UNITED STATES PATENT AND TRADEMARK OFFICE

APPLICATION NO.	FILING DATE	FIRST NAMED INVENTOR	ATTORNEY DOCKET NO.	CONFIRMATION NO.
10/508,981	09/24/2004	Gerhard Mock	04-439	1111

Office Action Summary

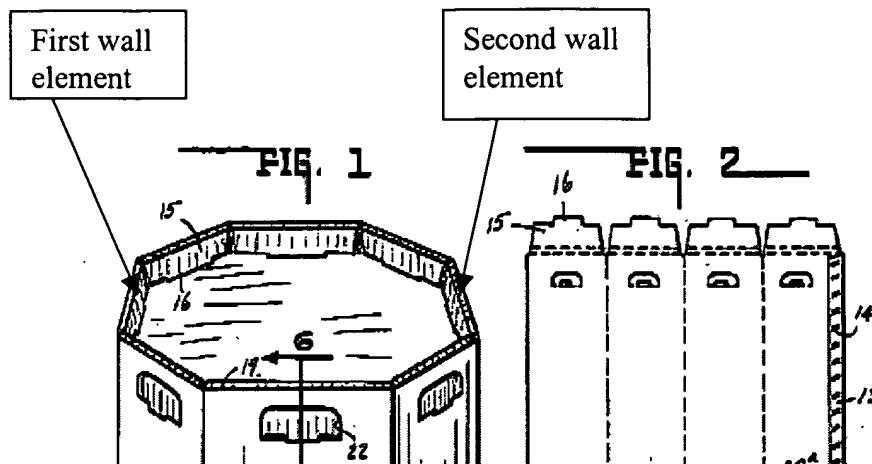
2. The specification is objected to under 37 CFR 1.71, as failing to provide an adequate written description of the invention and failing to adequately teach how to make and/or use the invention, i.e. failing to provide an enabling disclosure because the specification does not enable any person skilled in the art to which it pertains, or with which it is most nearly connected, to make and/or use the invention. The application fails to sufficiently describe the folding steps that how Figure 1 can become Figures 3-5 especially the gap 52, stamped edges 48, 50, stiffening means 56, 58 (the line in Figure 3) and others.

3. Claims 20-31 are rejected under 35 USC 112, first paragraph, as failing to comply with the enablement requirement. The claim(s) contains subject matter which was not described in

the specification in such a way as to enable one skilled in the art to which it pertains, or with which it is most nearly connected, to make and/or use the invention.
